Access Compliance Report Public Rights-of-Way (Curb Ramps)

Main Street: GILBERT_ST Cross Street: CERRITOS_AVE Location: SW

ADA ID: RPRK210923132628 Ramp Type: Type 1 - Perpendicular Diagonal Initial Pass/Fail: Pass Overall Compliance: No Severity Score: 13

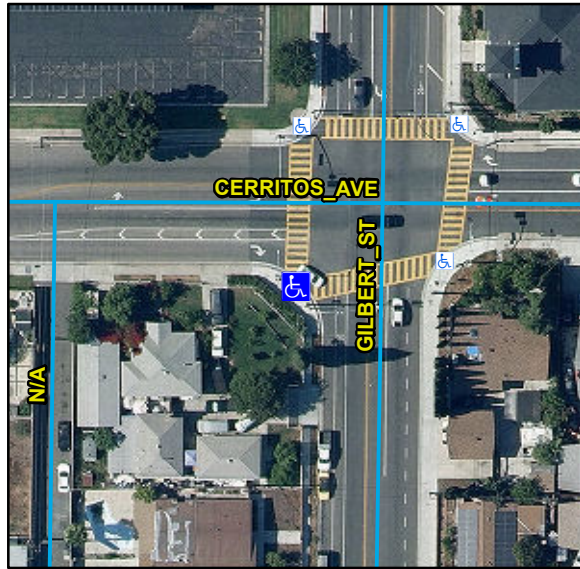
Compliance	Description	Data	Compliance	Description	Data
N/A	Ramp Length (in)	80	N/A	Flare Type LT	
Yes	Ramp Width (in)	48			Sloped
Yes	Ramp Run Slope (%)	7	N/A	Flare Slope LT (%)	8
Yes	Ramp Cross Slope (%)	0.4	N/A	Flare Traversable LT	No
N/A	Landing Present	Yes	N/A	Flare Type RT	
N/A	Landing Length (in)	30			Sloped
Yes	Landing Width (in)	48	N/A	Flare Slope RT (%)	8.9
No	Landing Run Slope (%)	2.2	N/A	Flare Traversable RT	No
Yes	Landing Cross Slope (%)	0.3	Yes	DWS Provided	Yes
N/A	Landing Movement Obstructed?	No	Yes	DWS Contrast	Yes
	Landing Movement Type	N/A	Yes	DWS Length (in)	36
N/A	Landing Shared	No	Yes	DWS Full Width	Yes
Yes	Clear Space	Yes	Yes	DWS Offset Left (in)	0
Yes	Clear Space To Crosswalk (in)	48	Yes	DWS Offset Right (in)	N/A
N/A	Marked Crosswalk 1	Yes	N/A	Marked Crosswalk 2	Yes
	Crossing 1 Direction	E		Crossing 2 Direction	N
	Marked Crosswalk 1 Width (in)	150		Marked Crosswalk 2 Width (in)	150
Yes	Ramp Inside Crosswalk 1	Yes	Yes	Ramp Inside Crosswalk 2	Yes

Crossing 1 Slope (%)	4.2		Crossing 2 Slope (%)	1.7
	Crossing 1 Cross Slope (%)	1.2		Crossing 2 Cross Slope (%)	1.5
Yes	Gutter Ponding	No	No	Curb Slope	5.6
Yes	Gutter Lip Height (in)	0		Road Run Slope (%)	0.2
No	Gutter Run Slope (%)	7		Road Cross Slope (%)	4.4
Yes	Gutter Cross Slope (%)	1.2			
Yes	Overall Surface Condition: Acceptable		Yes	Perp Joint Present	Yes
	Cross Gutter Present?	No		Spandrel Present?	No
	Replace Cross Gutter?	N/A		Replace Spandrel?	N/A

Remove & Replace Curb Ramp With Two New Directional Ramps or Equivalent. Remove & Replace Gutter.

R304.2.2, R304.2.1, R304.2.2-Perp, R304.3.2-Para, R304.5.4, STD 1115
